Certificate of Appropriateness

BAR 21-07-01
854 Locust Avenue, Tax Parcel 510092000
Martha Jefferson Historic Conservation District
Owner: Kaitlyn and Alan Taylor
Applicant: Ashley Davies
Project: Garage construction

**City of Charlottesville
Board of Architectural Review
Staff Report
July 20, 2021**

BAR 21-07-01

854 LOCUST AVE - Site Plan

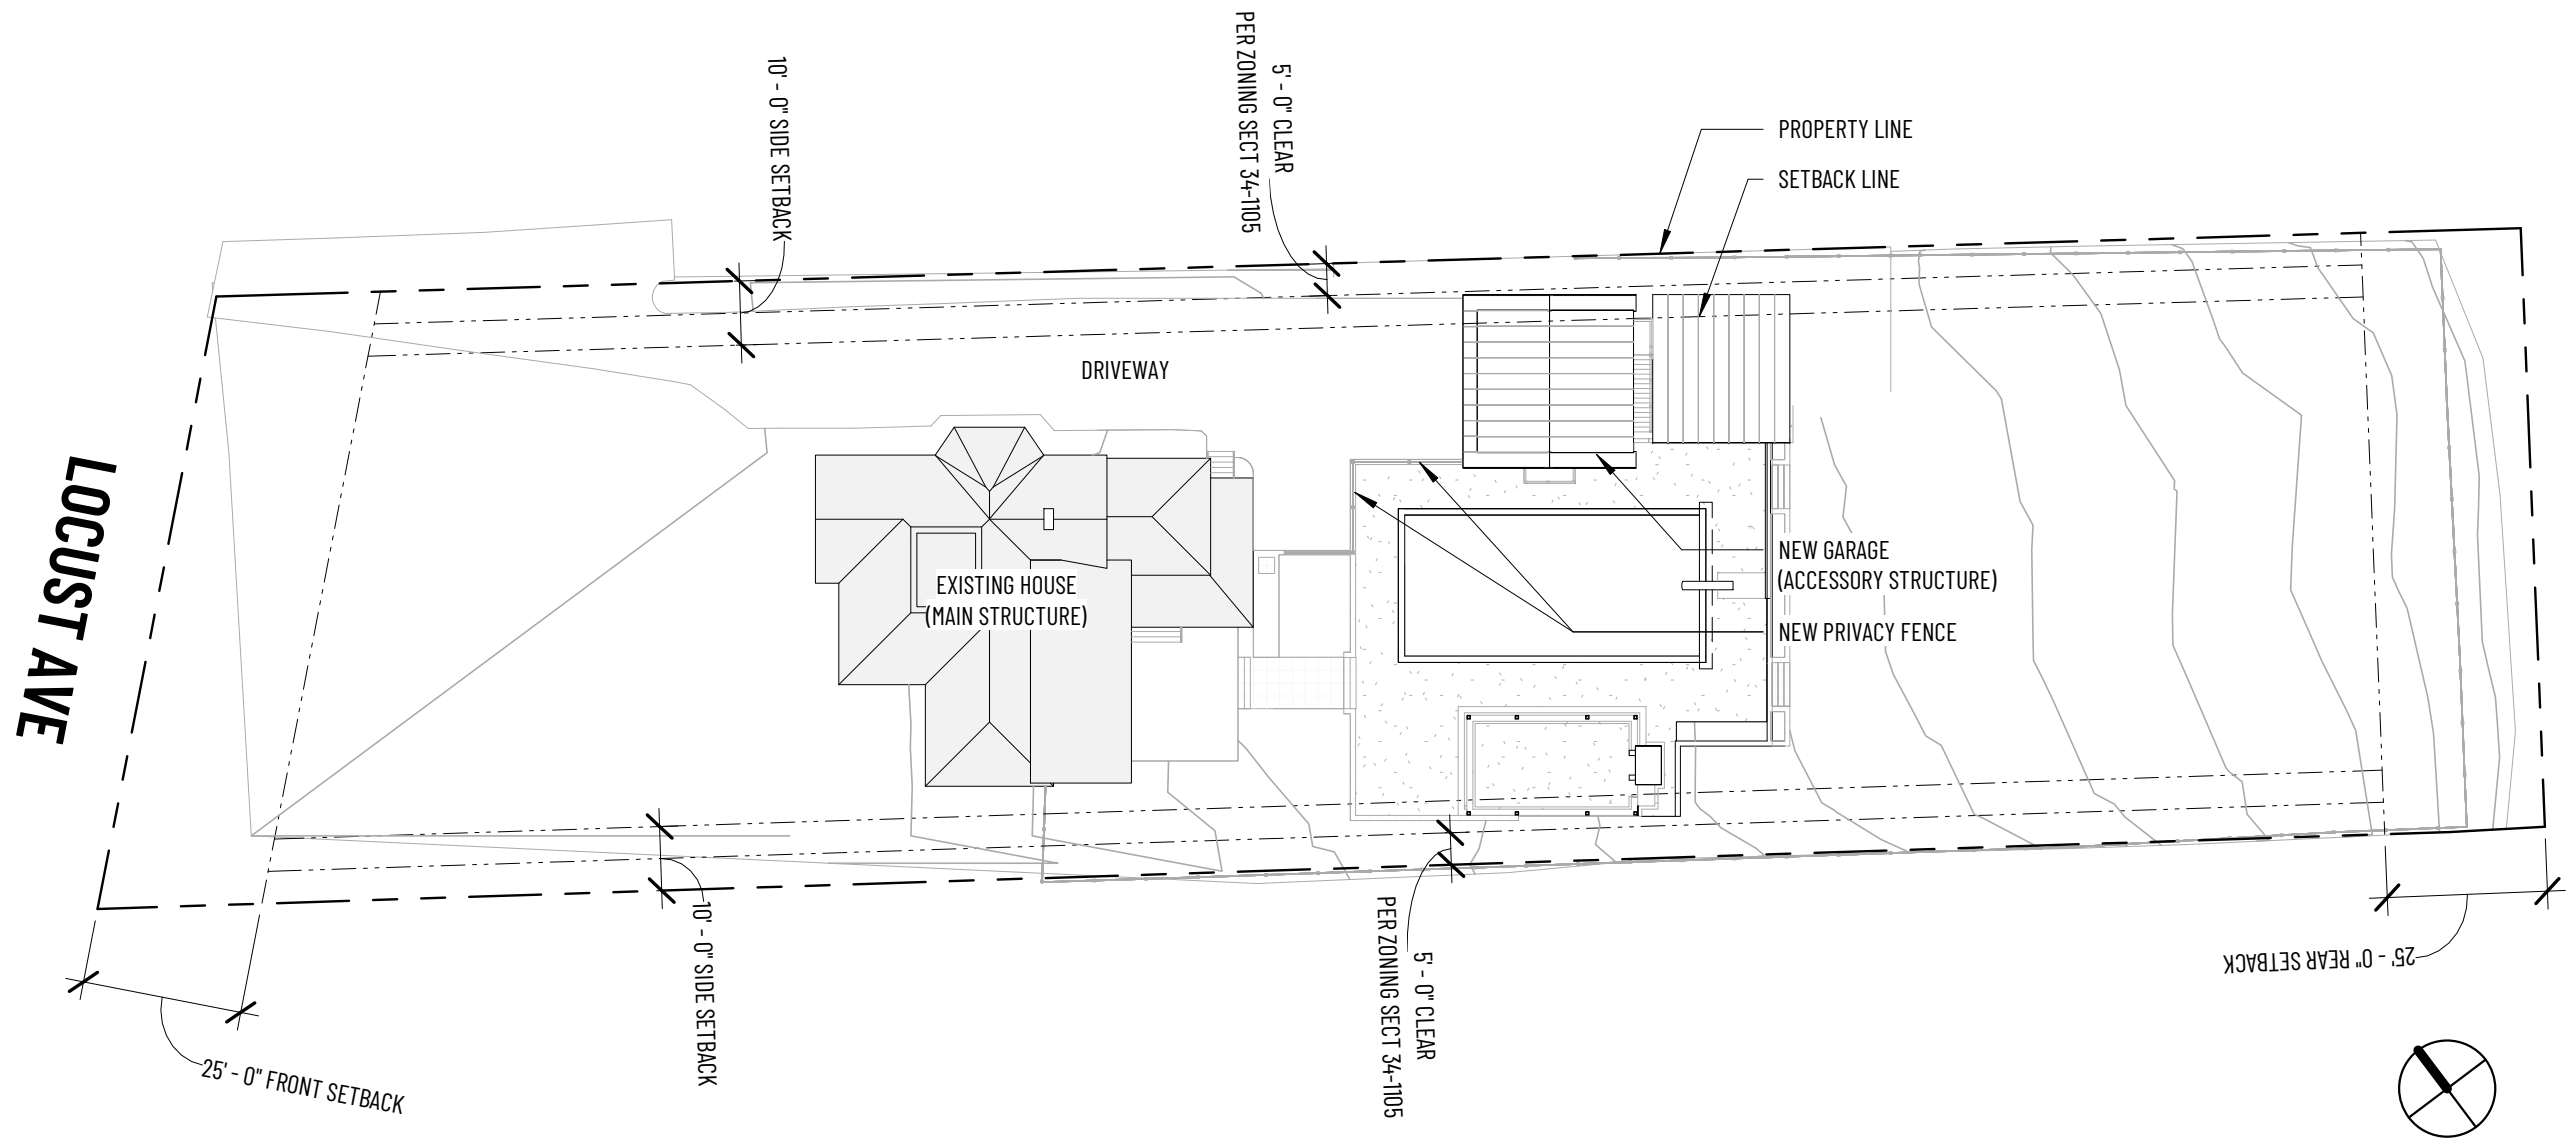
Staff Comment: Proposed garage is located in the rear yard and features a standing-seam metal roof.

2 Elev - Garage - Front

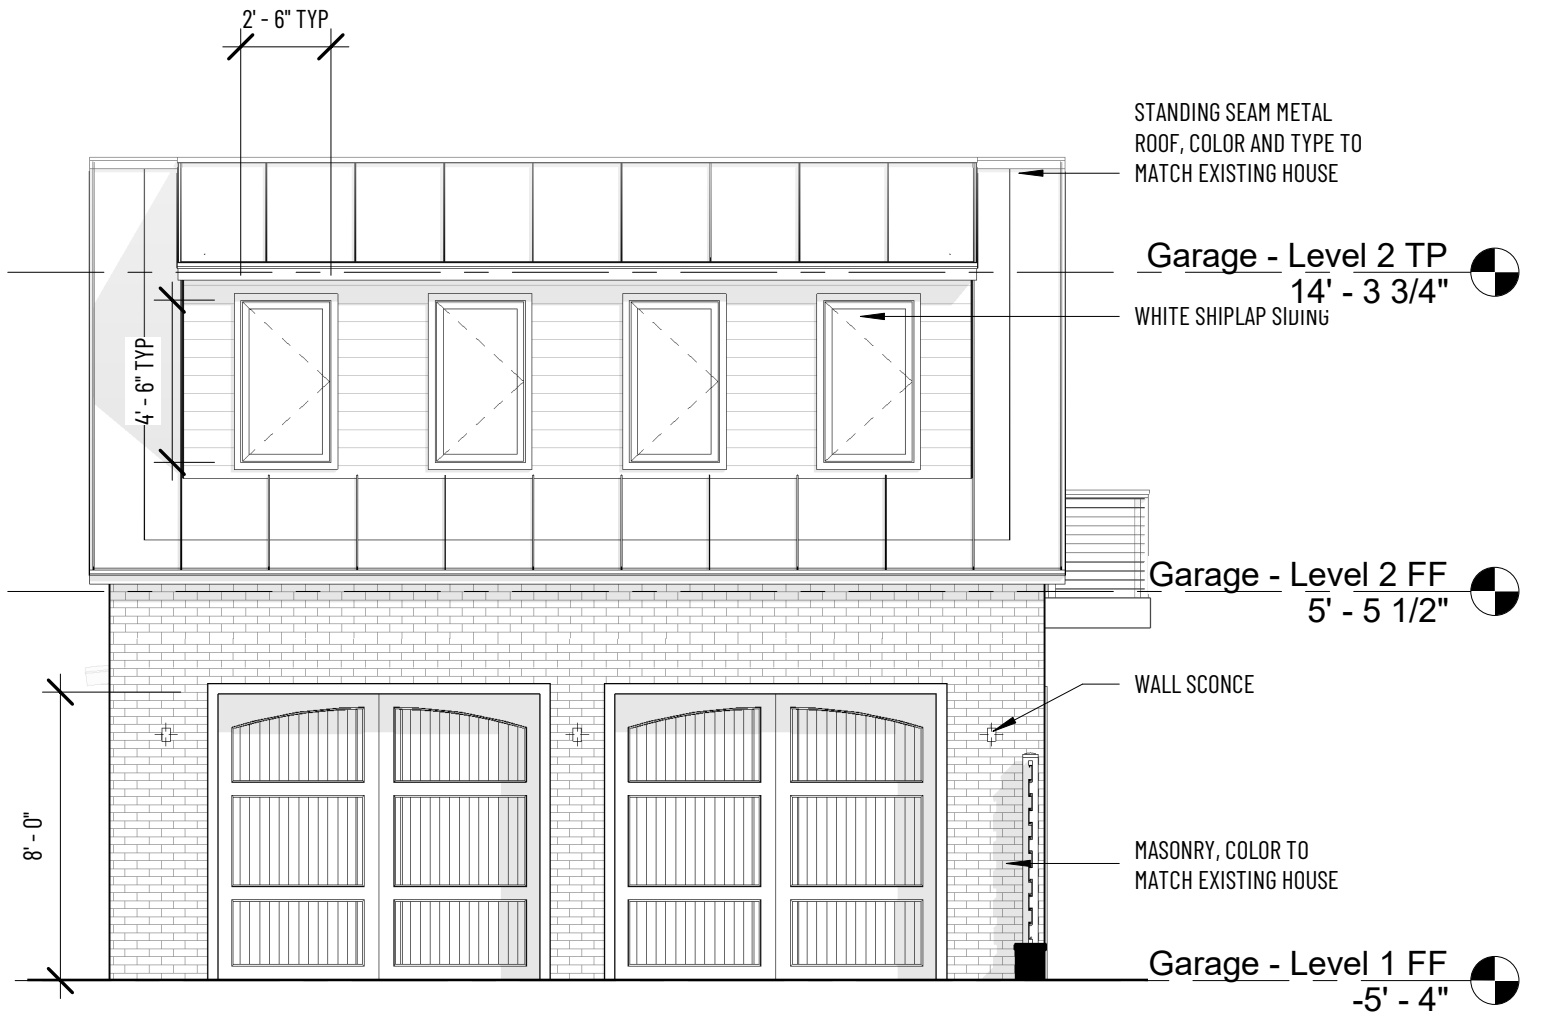
Within an HCD, the design review prioritizes what is visible from the public right of way. New structures concealed by the principal structure from all abutting streets are exempt from BAR review. With that, the four sides of the proposed garage are of the same design and materials, staff will focus on the front elevation.

Staff Comment: The garage is oriented towards the street. The arrangement and style of the doors and windows are compatible with the HCD.
